**SUBMISSION WITH RESPECT TO DRAFT MAMRE ROAD PRECINCT STRUCTURE PLAN UNDER STATE ENVIRONMENTAL PLANNING POLICY (WESTERN SYDNEY EMPLOYMENT AREA) 2009 ON BEHALF OF MAMRE ROAD HOLDINGS PTY LTD AND VAPOVI PTY LTD**

On Behalf of Vapovi Pty Ltd and Mamre Road Holdings Pty Ltd, 771-781 and 783-797 Mamre Road, Kemps Creek WTJ19-561

Figure 5 Proposed WSEA SEPP Zoning (DPIE, 2019)

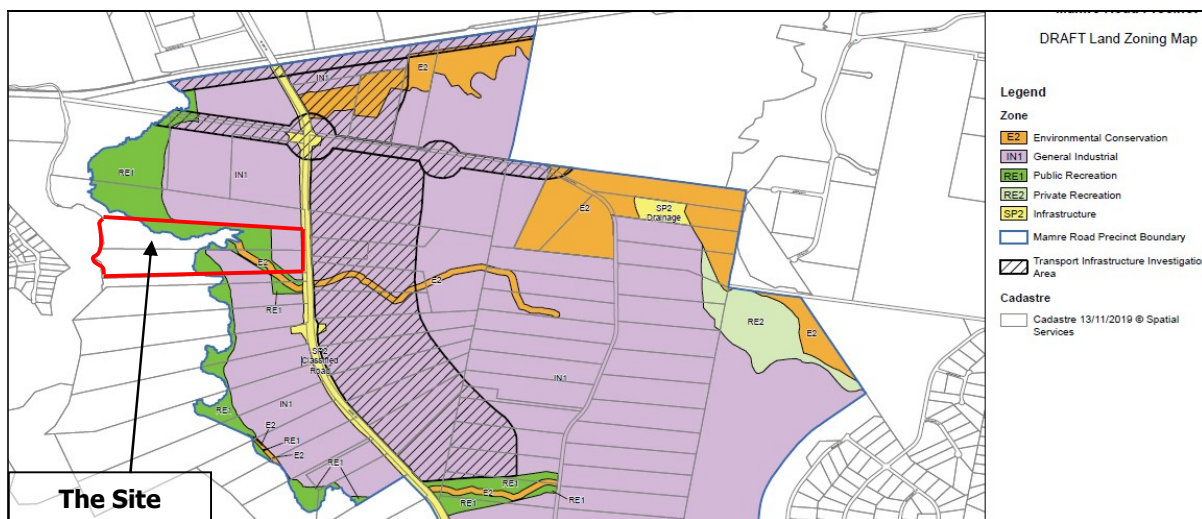
Portions of the site to the west would remain zoned RU2 Rural Landscape and E2 Environmental Conservation under the PLEP 2010, thereby removing their quasi industrial zoning which may be invoked using Clause 12 of WSEA SEPP. It appears that the eastern boundary of the site would retain its existing SP2 Infrastructure zoning, although it is not clear whether the extent of this zoning would increase as a result.

Introducing the extensive RE1 Public Recreation zone as is proposed under the Draft Mamre Road Precinct Structure Plan (refer to **Figure 5** below) would essentially 'downzone' the site, when compared to its current planning controls. Based on the mapping provided in the Draft Mamre Road Precinct Structure Plan, it can be concluded that the site would not be subject to the Transport Infrastructure Investigation Area overlay under WSEA SEPP (refer to area hatched black on **Figure 5** below).

The effect of the Draft Mamre Road Precinct Structure Plan would be to rezone around a quarter of the site as RE1 Public Recreation and E2 Environmental Conservation, cutting through the site's middle from north-west to south-east. This would result in Grave inefficiencies in the site's developable footprint, with two irregular shaped and relatively small pockets of IN1 General Industrial land created to the east and south.

**Figure 9 Proposed Rezoning Map (Sparks + Partners Consulting Engineers, 2019)**

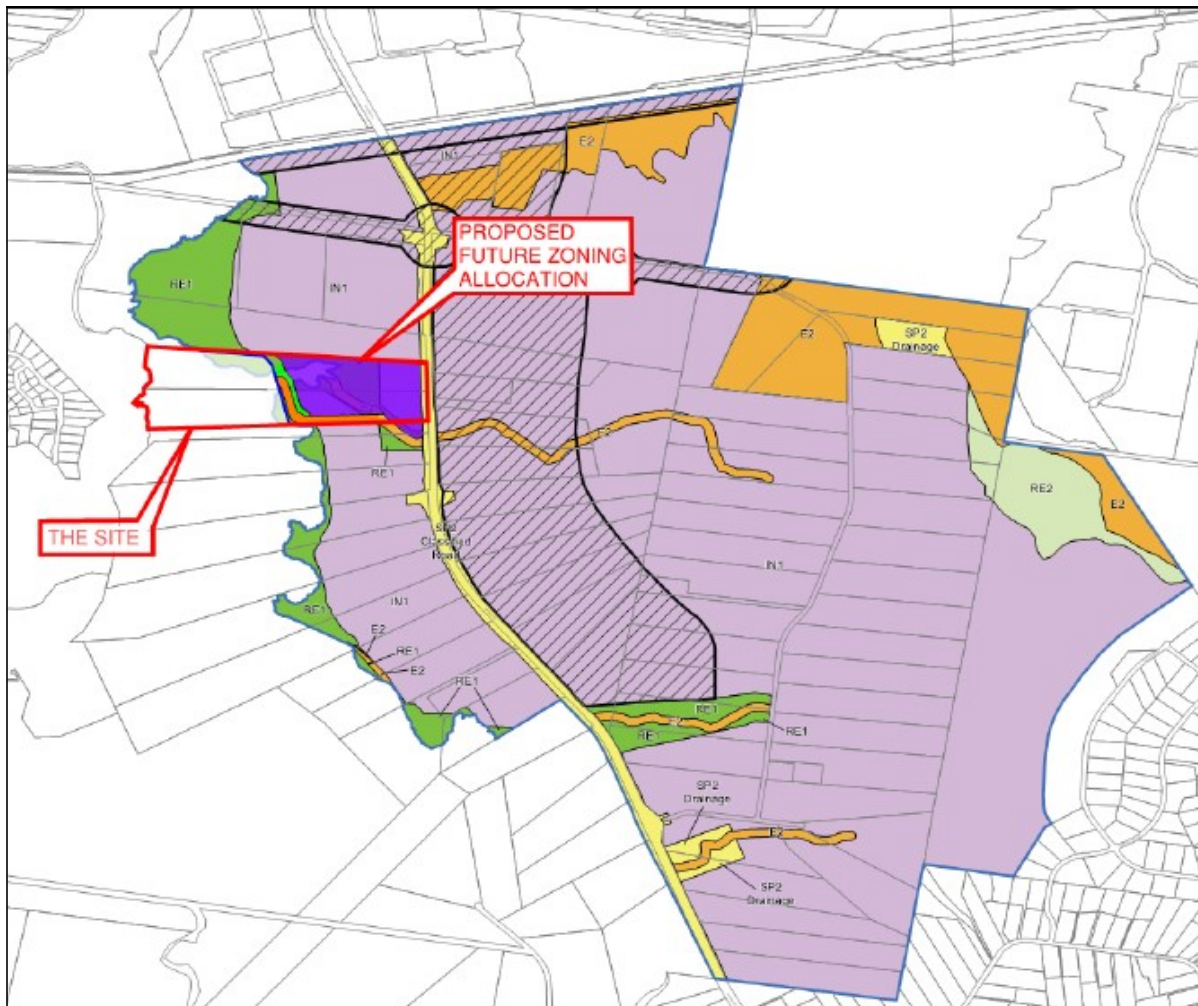
Overall, Vapovi and Mamre Road Holdings suggest that, should Government proceed with only half of its site within the WSEA, the IN1 General Industrial zone should apply to the entirety of the site's eastern half, as indicated on **Figure 9** below.

The alternative alignment of the RE1 Public Recreation zone as suggested by Vapovi and Mamre Road Holdings (refer to **Figure 9** in **Section 4.0** above) consists of geometric lines rather than an arbitrary one that would better reflect the intention and purpose of both the RE1 Public Recreation and IN1 General Industrial zones under WSEA SEPP. This would also allow for easier implementation and compliance during the development approvals and construction processes. **Figure 9** demonstrates how an appropriate open space offset could be provided. This alternative open space/conservation alignment would allow for a more streamlined approvals and construction process. It would also involve realigning the tributary to the southern boundary of Lot 24, before heading north along the proposed Mamre Road Precinct boundary located in the west of Lots 23 and 24 (refer to **Appendix 1**). The Draft Mamre Road Structure Plan zoning width of 40m indicates this tributary should be classified as a First Order Stream. Based on the *Guideline for Riparian Corridors on Waterfront Land* (Office of Water, July 2012), First Order streams are able to be realigned if required. Such a realignment would create less land fragmentation and prevent the creation of irregular-shaped land parcels. Ultimately, this would result in a better realization of:

As per **Figure 9** in **Section 4.0** above, Vapovi and Mamre Road Holdings consider that the spur protruding into Lot 23 can be removed through cut and fill earthworks, with cut from the western Precinct boundary line mapped as being RE1 Public Recreation (refer to **Appendix 1**). This approach would most likely result in a zero to positive flood storage offset with no detrimental effects to the flooding regime. The *Draft Exhibition South Creek Floodplain Risk Management Study* (Penrith City Council, 2019) shows this spur as being within the flood fringe/flood storage area. From an engineering perspective, flood storage and fringe areas can be developed, as they are not in the main floodway, as long as adequate assessment is undertaken (refer to **Appendix 1**). The *Draft Exhibition South Creek Floodplain Risk Management Study* (Penrith City Council, 2019) has assessed various flood risk/mitigation scenarios, including the impacts of cutting and filling within the floodplain. Vapovi and Mamre Road Holdings therefore submit that DPIE undertake further assessment in conjunction with Penrith City Council to understand the impacts of cutting and filling within this spur. Should the results be favourable, the precinct boundary as shown in **Figure 9** above could be considered for implementation. Such an outcome would better reflect the requirements of the Mamre Road Precinct whilst also managing the requirements of the South Creek Catchment and floodplain. Such a realigned Precinct boundary would also have a positive effect on any future local collector road alignment. By realigning the Precinct boundary, a collector road is able to be easily provided with any future road reserve linking the north and south areas of the western side of the Mamre Rd precinct (refer to **Appendix 1**).

Figure 10 Draft Mamre Road Precinct Flood Affection (NSW DPIE, 2019)

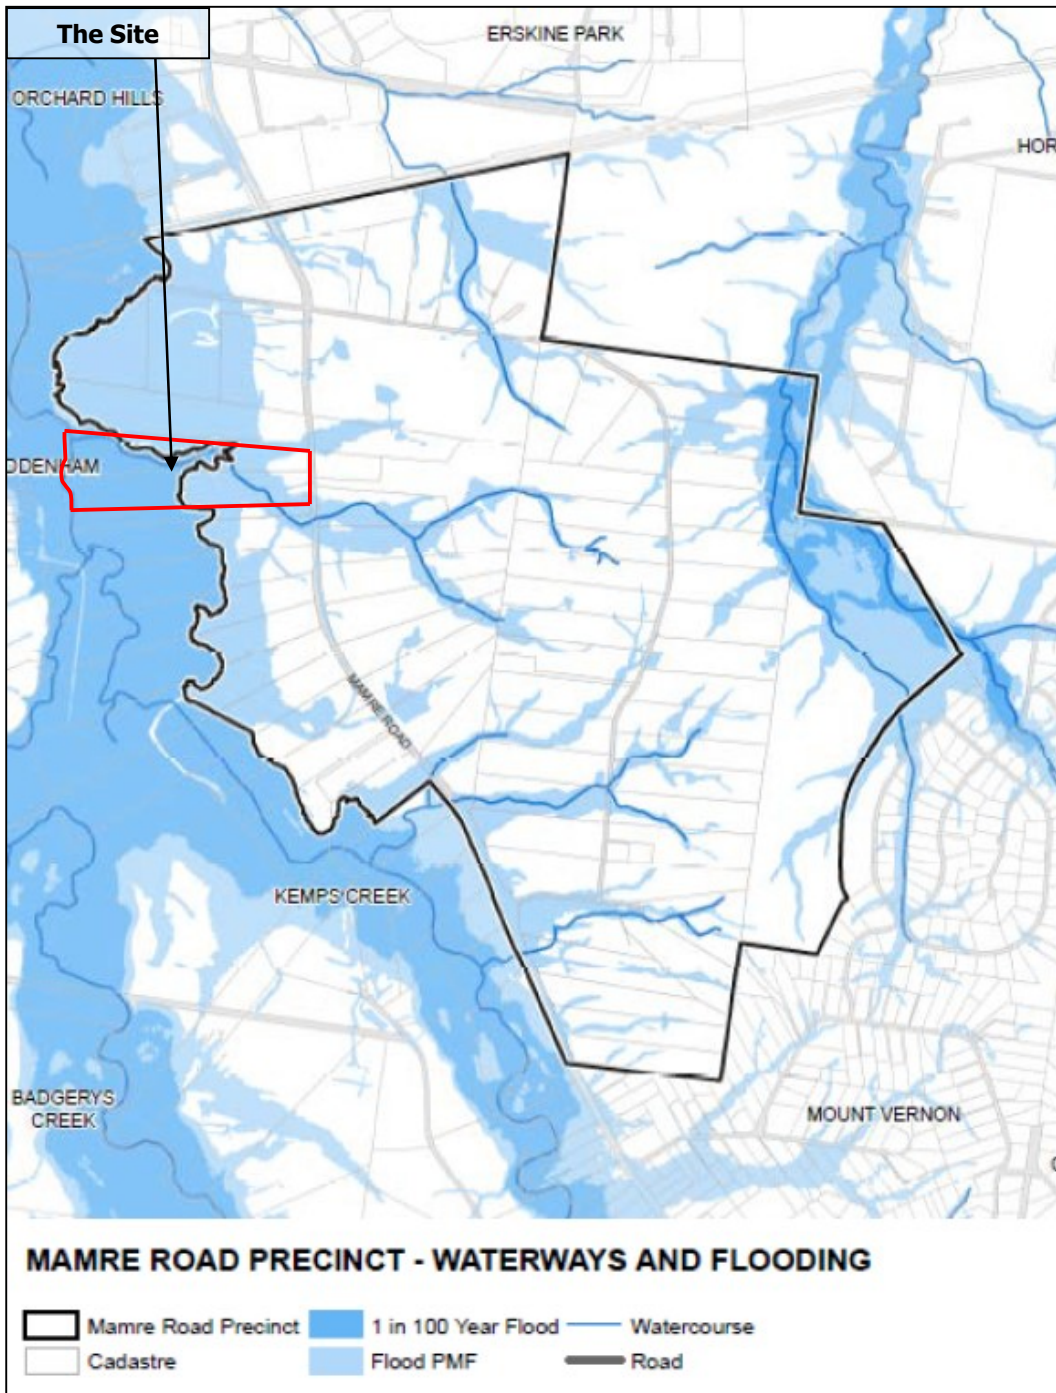
flood risk reasons why much of this land cannot be developed for industrial or other purposes. Overall, Vapovi and Mamre Road Holdings reject the extent of this RE1 Public Recreation zoning running through the middle of the site (refer to **Section 4.9** below for more details). On this point, the Discussion Paper is also considered to be misleading as it does not specify that no built form would be permitted in the extensive RE1 Public Recreation zone. However, given the stringent application of flooding levels to define the buildable zone within the Precinct, it can be inferred that this is the intent of the Draft Mamre Road Precinct Structure Plan. In contrast, it is considered that there are various compatible built form land uses that could be undertaken within the RE1 Public Recreation zone should this zone be formalised within the Precinct (refer to **Section 4.9** below).

Figure 1 - DRAFT Land Zoning Map (NSW Government, Planning Industry & Environment, 2019)

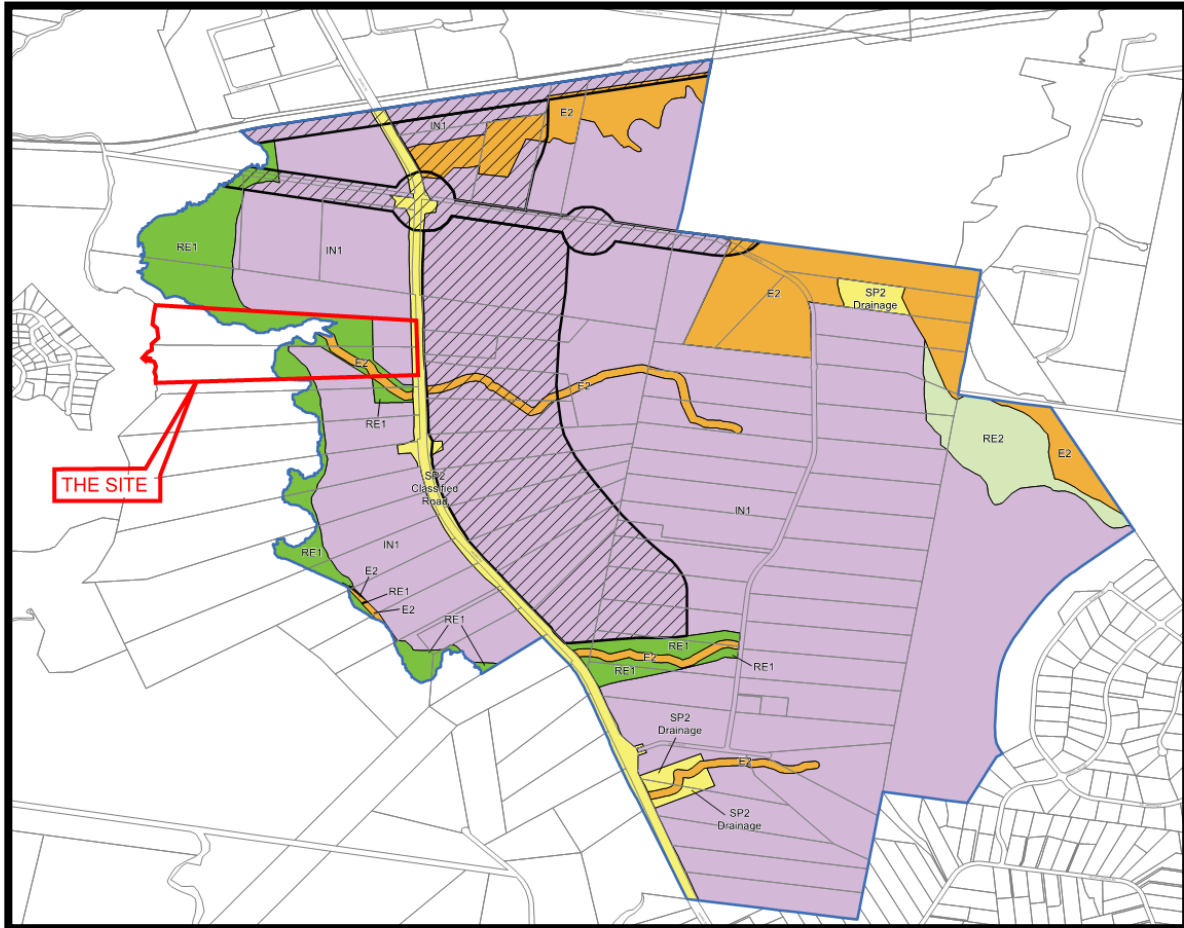
The proposed land zoning is a mixture of IN1, RE1 and E2. The extent of the Mamre Rd precinct along its western boundary appears to follow the 1:100yr ARI flooding extents as detailed in both the Updated South Creek Flood Study, January 2015 prepared by Worley Parsons for Penrith City Council, and the Exhibition Draft South Creek Floodplain Management Study and Plan, August 2019 prepared by Advisian for Penrith City Council. This precinct boundary dissects the properties approximately halfway along the southern boundary, with a central spur running into the properties to the east before dissecting the properties toward the west on the northern boundary. From the precinct boundary an RE1 zone has been allocated to the east with the extent appearing to be arbitrary as it does not relate to any available flood mapping or other environmental considerations. The proposed E2 zone alignment follows the route of an existing tributary of South Creek which originates from the east of Mamre Road in Lot 35 DP258949 and flows west through nine (9) properties before discharging to South Creek. This route travels from the south east to the north west through the eastern portion of the subject properties. An RE1 zone has been setback around this E2 zone and again appears to be arbitrary in its allocation. The remainder of the lot parcels is zoned IN1 which results in two irregular shaped portions of land located on the eastern side and southern sides of the properties. Figure 1 and 2 show

The proposed zoning impacts result in fragmented and irregular shaped developable land parcels. The IN1 land parcels are not connected to the north and south IN1 zones where proposed road networks are most likely to be located. Any future local road would most likely dissect these proposed zones locations resulting in further fragmentation of the land parcels and the objectives of the precinct plan not being realised.

The proposed E2 zoning alignment follows the existing tributary, however the likelihood that this alignment will remain in this form is considered low. The tributary is the result of a minor catchment that is located to the east and conveys overflows from rural dams located in this area. Historical photos show the tributary has intermittent flows with periods of little or no flow, therefore not being suitable for fish habitat. The alignment dissects the site and results in IN1 land parcels that are fragmented from the main IN1 zones to the north and south, and also the result in irregular shaped land parcels would be difficult to develop given the geometrically square nature of warehousing and industrial developments. In this regard any future development would most likely result in a submission to the department to have this E2 zone realigned to allow for better realization of the land in accordance with the objectives to the precinct plan.

Figure 3 - Proposed Land Zoning Map

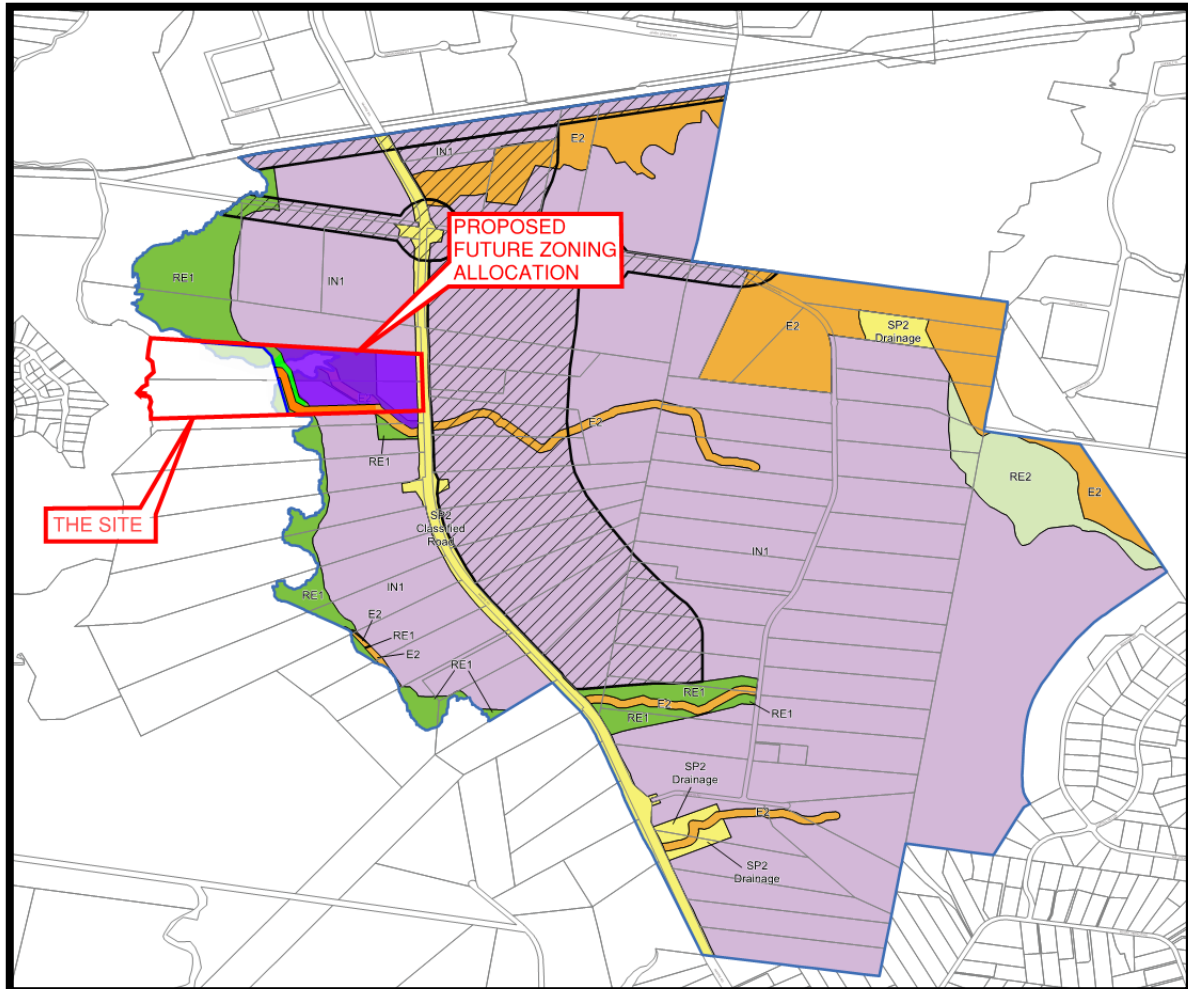
The proposed amendment to the precinct boundary is to remove the spur that protrudes into the Lot 23. This can be achieved through cut and fill earthworks to fill in the spur area with cut from the west of the precinct boundary line currently designated as RE1. This proposal would most likely result in a zero to positive flood storage offset with no

The proposed amendment to the RE1 zone is to provide an alignment that consists of geometric lines rather than an arbitrary line that better reflect the intention and the purpose of RE1 and IN1 zones and would allow for easier implementation during the development approval process and ultimate construction on-site. The proposal would involve a designated offset from the RE1 precinct and E2 boundary which can be clearly shown on any future development proposals. Figure 4 – Proposed Land Zoning Map shows the proposed road alignment and precinct boundary.

The proposed amendment to the E2 zoning consists of realigning the tributary to the southern boundary of Lot 24 and then heading north along the proposed precinct boundary located in the west of Lot 23 and 24. The tributary appears to be classified as a 1<sup>st</sup> Order stream based on the approximate 40.0m width allocated within the DRAFT Land Zoning Map. Based on the NSW Government Department of Primary Industries, Office of Water, Controlled Activities on Waterfront Land – Guideline for Riparian Corridors on Waterfront Land, July 2012, 1<sup>st</sup> Order Streams are able to be realigned if required. This realignment results in less fragmentation and irregular shaped land parcels ensuring the overall objectives of the precinct for utilisation of the IN1 zones and environmental consideration

of conveyance of overland flows from the upstream catchment located to the east. Figure 3 – Proposed Land Zoning Map shows the proposed E2 zone location.

Figure 4 - Proposed Land Reservation Acquisition and Precinct Road Alignment

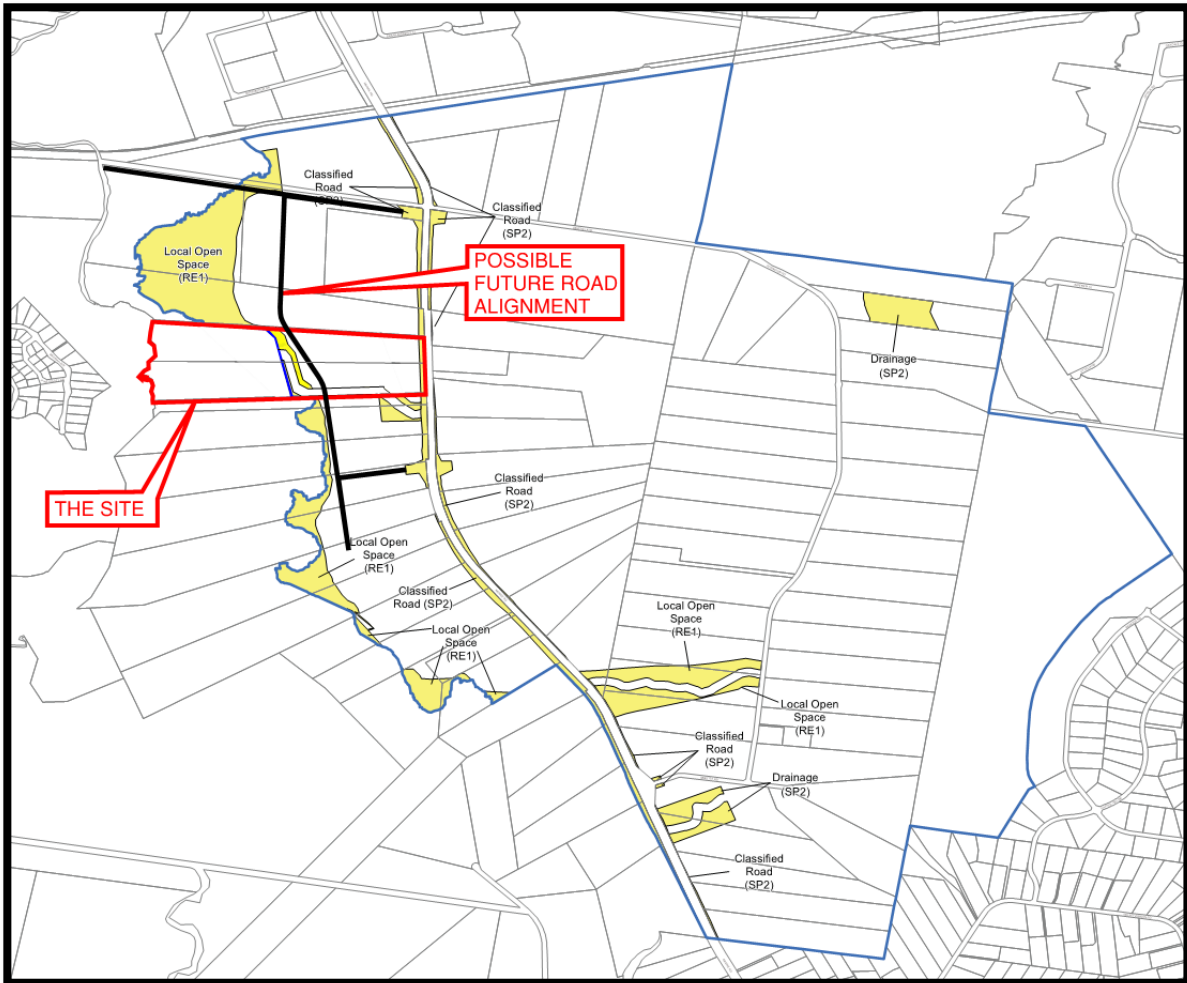
The realigned precinct boundary will also have a positive effect on any future local collector road alignment. By realigning the precinct boundary, a collector road is able to be easily provided with any future road reserve linking the north and south areas of the western side of the Mamre Rd precinct. Figure 4 – Proposed Land Reservation Acquisition shows the proposed Precinct Boundary location
